## Canterbury Bankstown Local Planning Panel - 30 September 2019

**ITEM 1**                      **Planning Proposal: 74 Rickard Road and Part 375 Chapel Road, Bankstown**

**AUTHOR**                      **Planning**

Figure 5: Cross-Section of the Proposed University

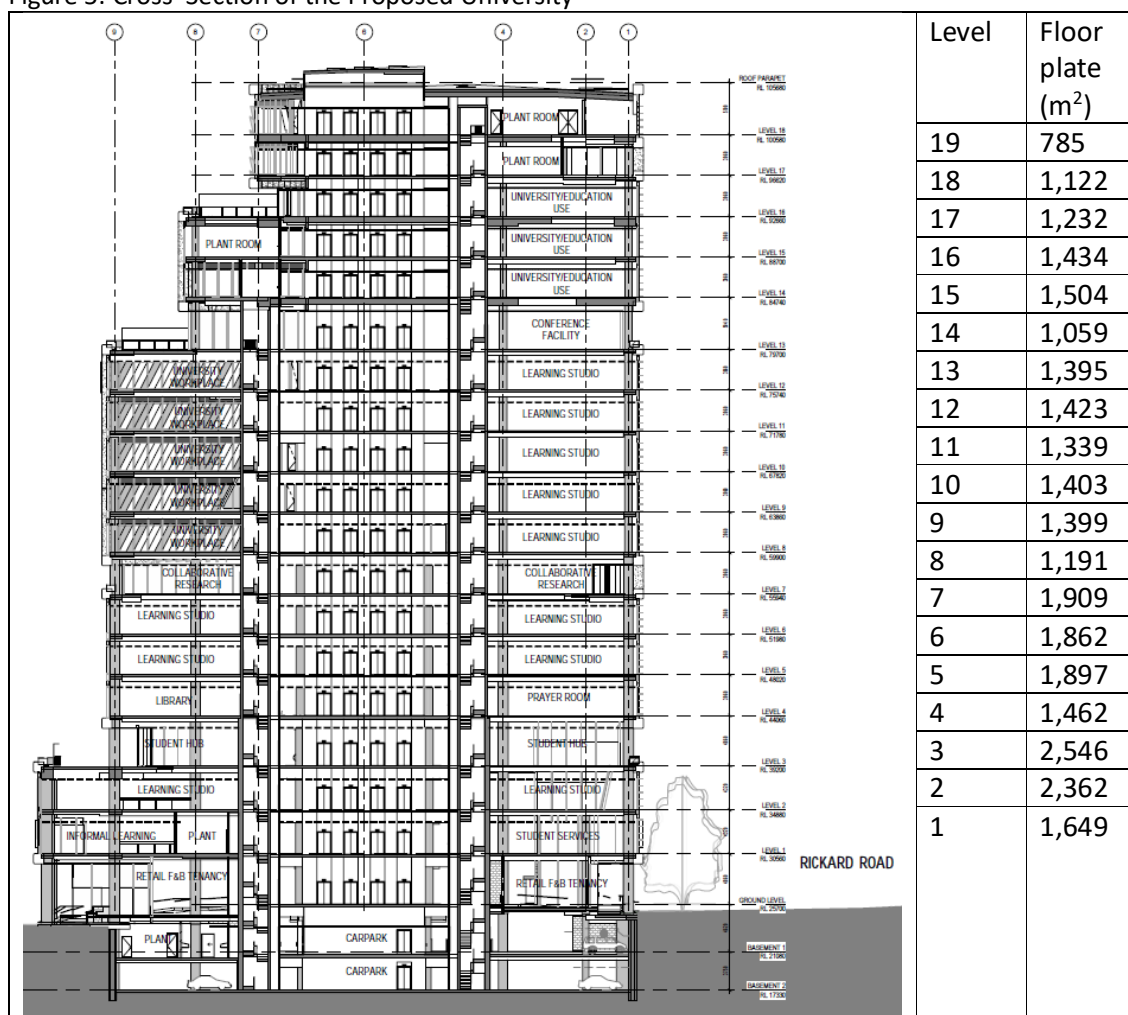
According to the Planning Proposal Report (Attachment C, page 41) and additional letter (Attachment G), the proposed floor space and floor plates are required:

Source: WSU Site Flood Assessment Report (Attachment V, page 9)

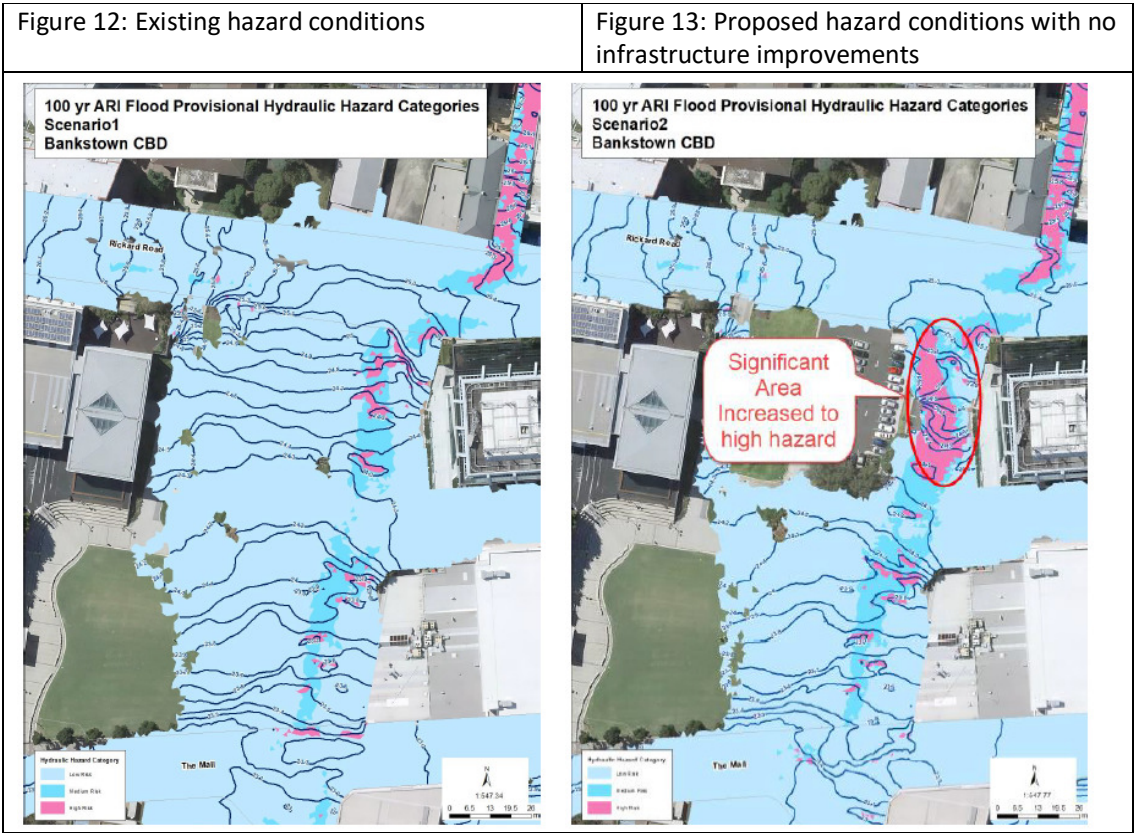
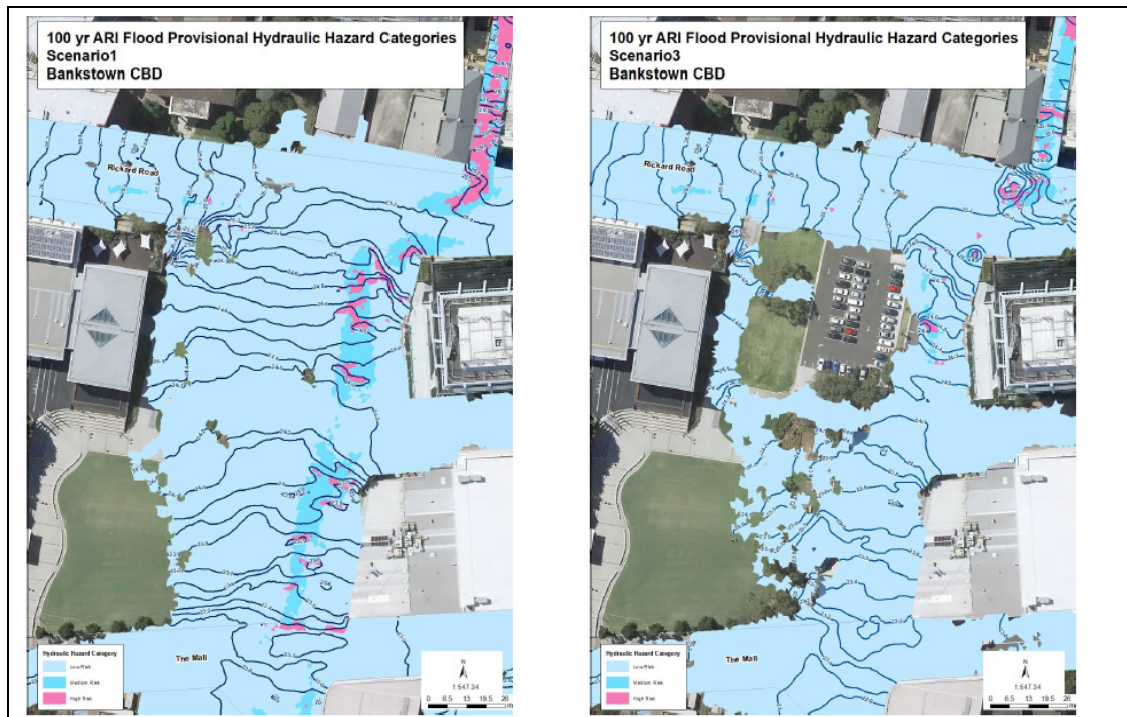
In relation to existing conditions, the site forms part of the Salt Pan Creek upper catchment and is affected by an overland flow path, stretching from Rickard Road to the open channel at North Terrace. The maximum water depth on the site is 0.61 metres in a 100 year flood event (Attachment V, page 8). This is due to the inadequate capacity of the existing stormwater system and blockages that occur to stormwater pits and culverts, in particular at North Terrace which impacts on the drainage capacity of The Appian Way.

The proposal would block part of the overland flow path, making flood conditions more hazardous between the proposal and the Civic Tower (refer to Figure 13). The maximum water depth would increase from 0.61 metres to 0.87 metres in a 100 year flood event and would increase the extent of high risk stormwater flooding (Attachment V, page 8).

While a freeboard is a common safeguard to minimise risk on the site, it is recommended that further infrastructure works be delivered that would mitigate flooding impacts associated with the building, noting that these works would include broader stormwater infrastructure beyond the site.

Proposal	Peer Review Recommendations
<p>The proposal does not propose infrastructure improvements to mitigate the impacts as a result of the proposal.</p> <p>The proposal comments that Council should request Sydney Water to upgrade the Stacey Street canal and investigate ways to upgrade the canal along The Appian Way to minimise the potential flood impact on the site (Attachment C, page 39).</p>	<p>Introduce capacity improvements to the existing stormwater system to manage increased flood water levels as a result of the proposal.</p> <p>This would require an additional culvert at North Terrace, which would significantly reduce the flood impacts both on and off the site (refer to Figure 15). The maximum water depth would reduce from 0.61 metres to 0.52 metres in a 100 year flood event and would reduce the extent of high and medium risk stormwater flooding (Attachment V, page 11).</p>

Should the proposal proceed to Gateway, the recommended action prior to exhibition is:
